# Illinois Department of Transportation

SUBJECT: Lincolnwood Valley (Line Trail)  
Section 12-00059-00-BR (Lincolnwood)  
Cook County  
Contract No. 61D97  
Item 15  
August 4, 2017 Letting  
Addendum (A)

## NOTICE TO PROSPECTIVE BIDDERS:

EXHIBIT A

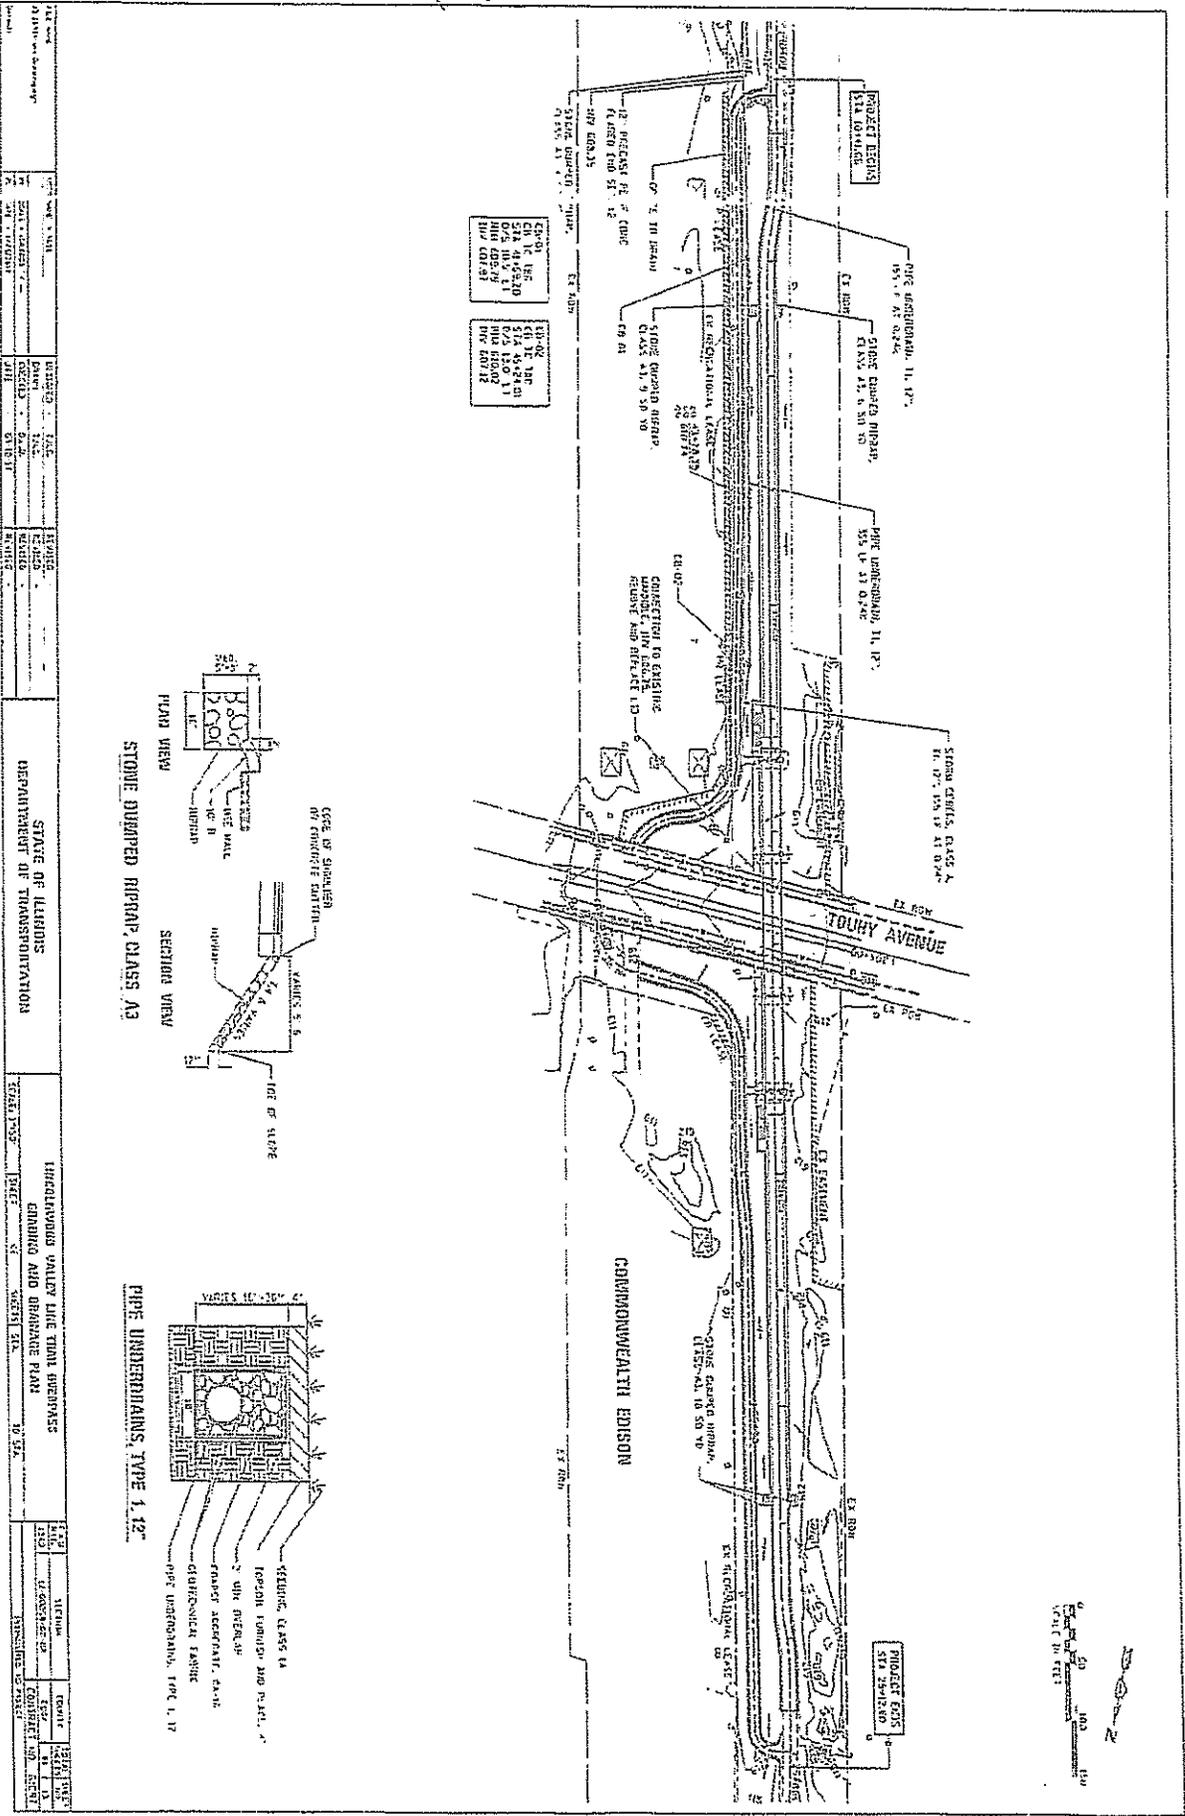
2. Pursuant to Section 9 of the Lease, Landlord hereby consents to the following Alterations: (a) installation of a Pedestrian Bridge over Touhy Avenue on the existing recreational trail as depicted on the attached Exhibit A; (b) re-directing a portion of the existing recreational trail towards the proposed Pedestrian Bridge as depicted on the attached Exhibit A; (c) installation of a underdrain and storm sewer system that will accept the drainage and maintain the outlet by connecting directly to the manhole located on the south side of Touhy Avenue on the recreational trail as depicted on the attached Exhibit A, all such Alterations are subject to the terms and conditions of Section 9 of the Lease, including installation of such Alterations in accordance with the plans and specifications reviewed and approved by Landlord. For the avoidance of doubt, Tenant shall be responsible, at Tenant's sole cost and expense, for maintenance (and, at Landlord's election, removal) of the Alterations approved herein.
